CASS COUNTY CUP APPLICATION DUE DILIGENCE REPORT

CASS COUNTY

PROJECT NO. 175401

REVISION 1

Figure 1: Solar Site Plan

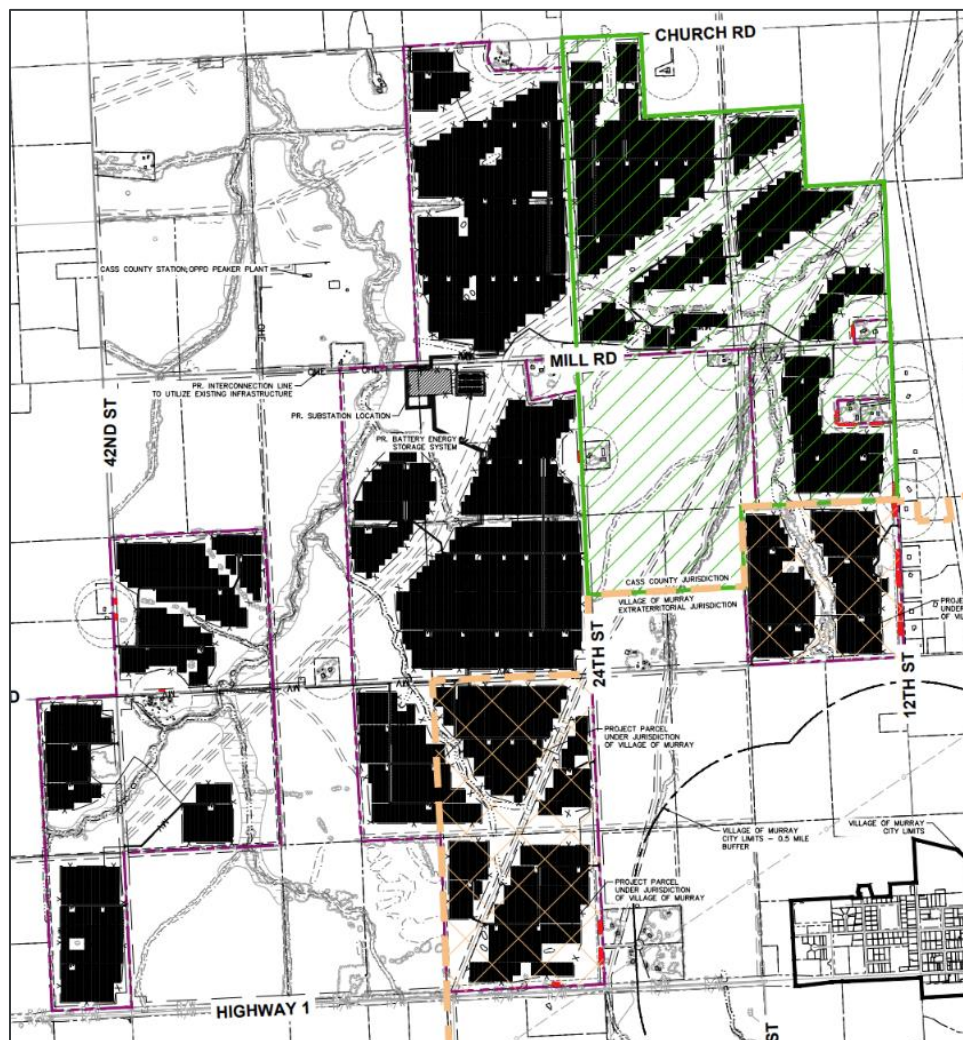
All setbacks stated to be used in the provided site plan match what is required by Cass County, though the setback from Conestoga Jr./Sr. High School does not appear to be applied appropriately if the 500-foot residence setback also applies to schools.

- A ground coverage ratio ("GCR") of 38.0% is higher than what is typical in the industry, 30.0% to 34.0% is more common. Although this results in increased shading effects leading to reduced annual energy production, this does not affect the county or impede the applicant's ability to comply with ordinance requirements.

- A module bin class and inverter megavolt-ampere ("MVA") rating are not provided. It is unclear how values for direct current ("DC") and alternating current ("AC") capacity are being calculated at the time of this report as these ratings are foundational to capacity.

- Conestoga Jr./Sr. High School is located SW of the intersection at Highway 1 and 42nd Street. Modules are planned to be installed within 350' of this school, which would violate the 500' residence setback required by Cass County ordinance if applicable. Excluding this instance, setbacks are applied as required by Cass County ordinance and typical industry standards.

- Wetland disturbances during construction are very likely due to the presence of streams throughout the site. These streams will need to be bored during construction to allow for underground medium voltage collection, though this process is understood to have minimal impacts on the surrounding environment when performed properly.

- Laydown yards and stormwater retention ponds are absent from the provided site plan. NextEra will need to ensure that sufficient space is set aside for these pieces of infrastructure to mitigate impacts to local traffic and local wetlands respectively.

Figure 2: Single Line Diagram

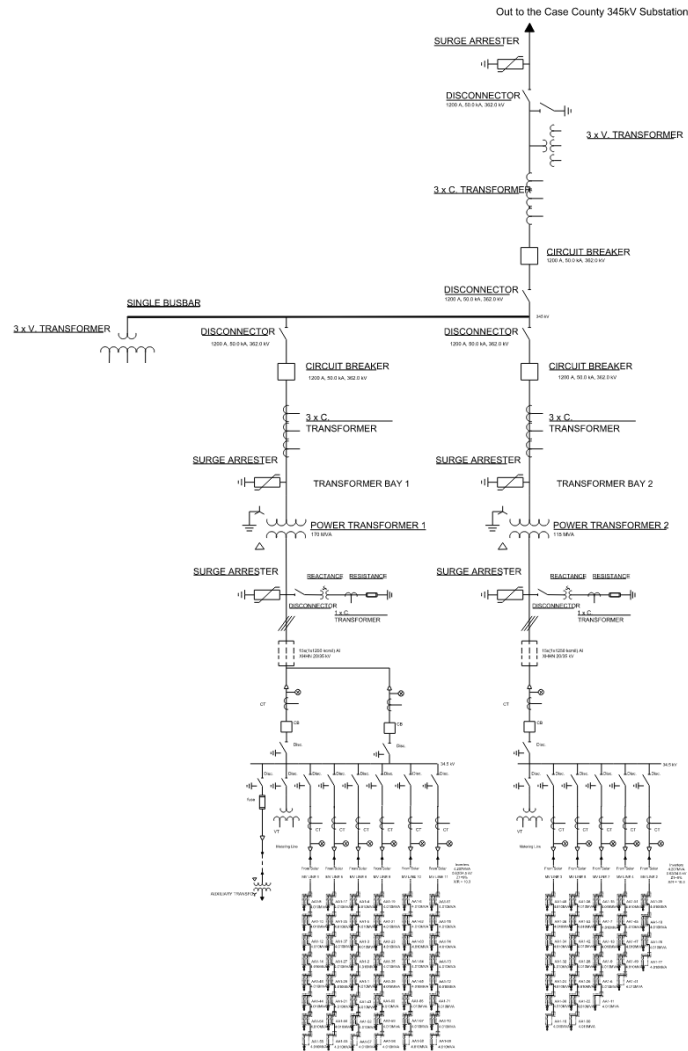
- Some relevant ratings for equipment are absent from the single line diagram. Voltage ratings are excluded from the MPT's and the MV breakers
- Several of the ratings present in the single line diagram are inaccurate or incorrect, including the grid voltage. However, this diagram appears to be a generally accurate representation of the proposed site.
- MPT 1 should be confirmed to be sized adequately to withstand the maximum power of 201.9 MVA which is shown to be connected to it. This is of particular concern as MPT 1 is shown to be rated at 170 MVA, 31.9 MVA short of this maximum power.

While the SLD was lacking finalized ratings, 1898 & Co. recommends requesting a finalized SLD from NextEra before a building permit is issued, if applicable. Provided the final SLD is adequately submitted before construction, 1898 & Co. identified no fatal flaws based on the data provided.
